AMENDMENT NO. 3 JANUARY 1992

IS 2325 : 1981 SPECIFICATION FOR IGNITION COILS FOR BATTERY-COIL IGNITION SYSTEMS FOR AUTOMOBILES

(First Revision)

3A Schematic Diagram of Test Set-Up

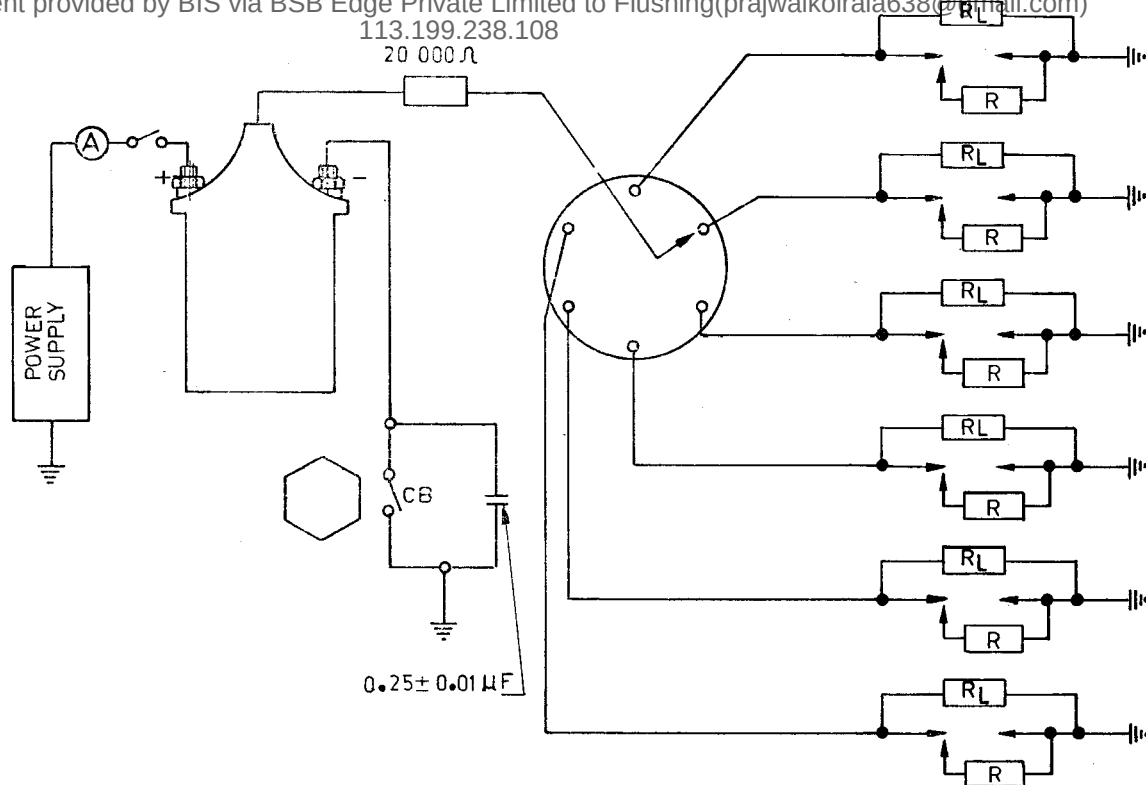
(Page 11, Fig. 3A) — Substitute the following for the existing figure:

NOTE 1 — Contact breaker close period shall be set to:

- $39 \pm 0.5^\circ$ for 6 lobe cam
- $57 \pm 0.5^\circ$ for 4 lobe cam

NOTE 2 — Power supply shall be as specified in the relevant clause.

NOTE 3 — The coil shall be held in the vertical position with the terminals upwards.

NOTE 4 — 4 or 6 lobe cam of associated distributor shall be used for the test.
